PROJECT NOTES

PROJECT NAME:	BRIDGEWATER-CHESTER-THETFORD
PROJECT NUMBER:	ST BPNT(2)
FILE NAME:	\\Bridge.Chest.The\Notes.dgn
DATE:	7/3/2008
PROJECT LEADER:	G. BOGUE
DRAWN BY:	J. SOTER
DESIGNED BY:	S. BURBANK
CHECKED BY:	M. CHENETTE
PROJECT NOTES AND DETAILS	SHEET 4 OF 16

AREAS OF PAINT REMOVAL FOR BRIDGES 16, 25 & 40

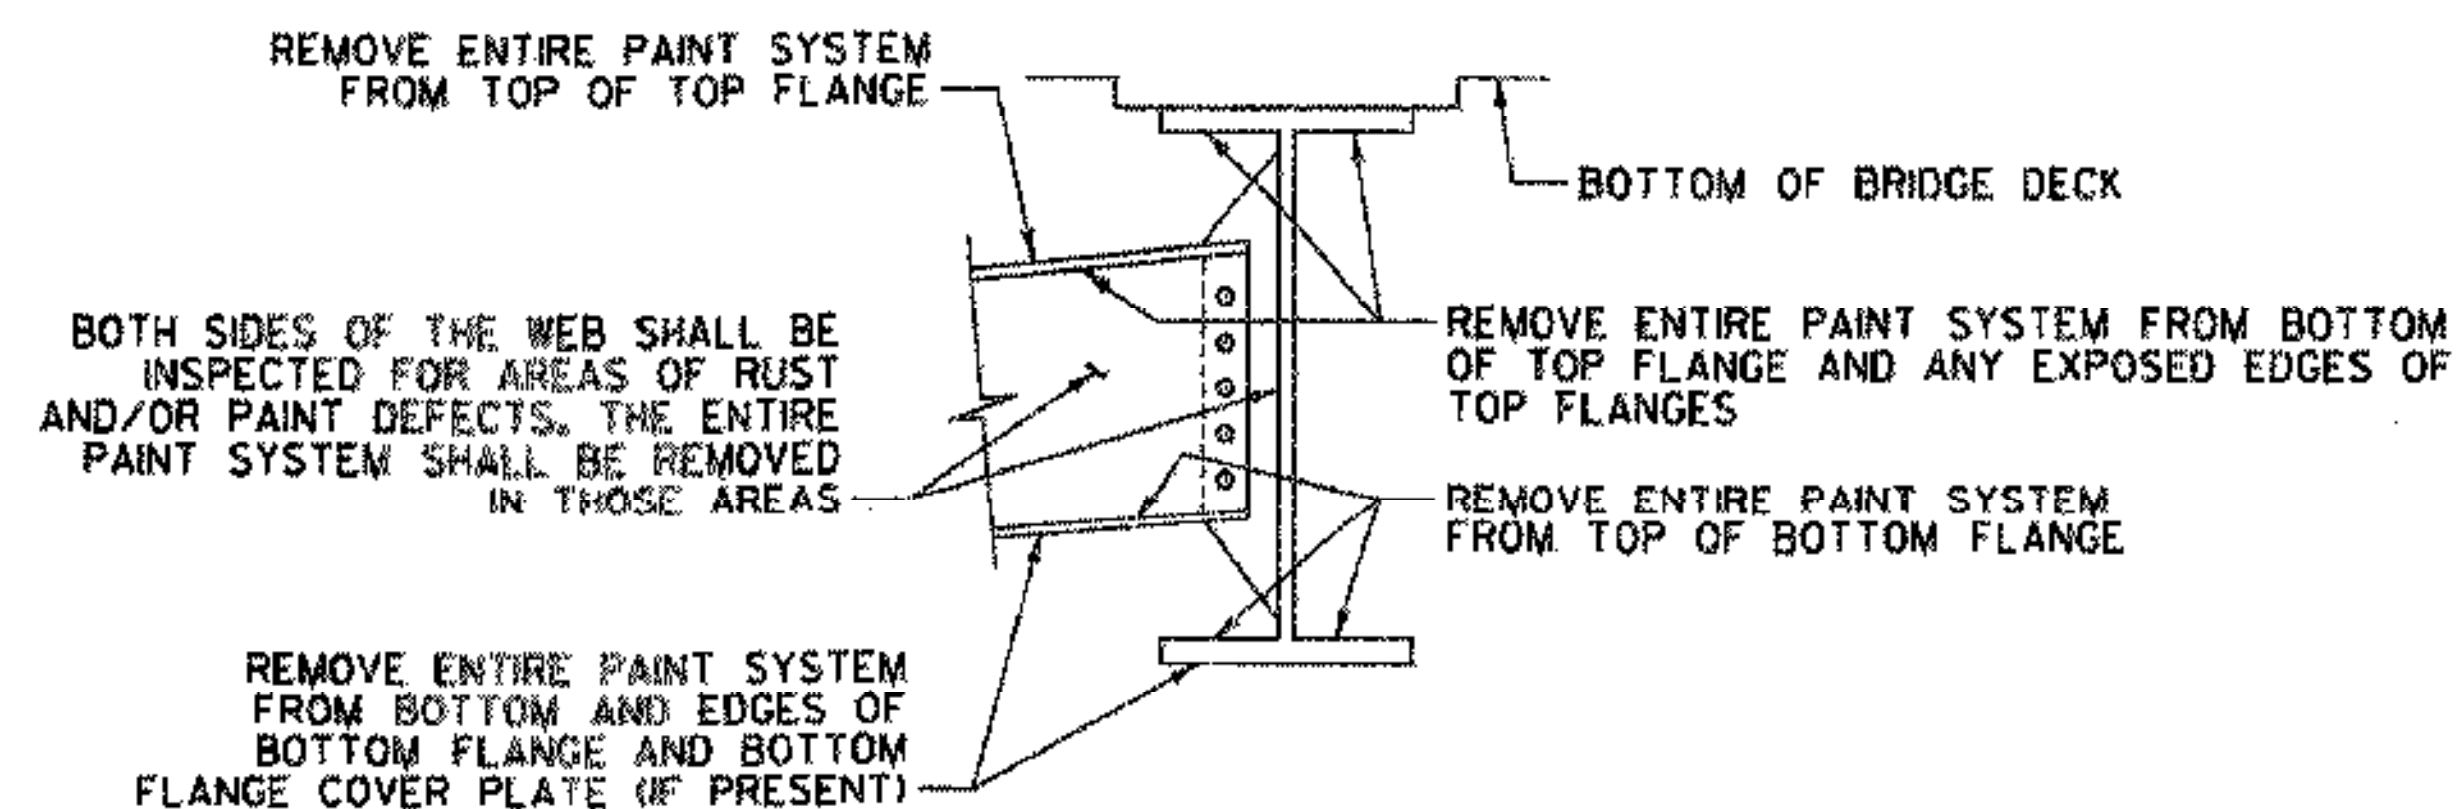
TIE COAT APPLIED BETWEEN OLD PAINT AND NEW PAINT. THIS ITEM ADDED PER CHANGE ORDER.
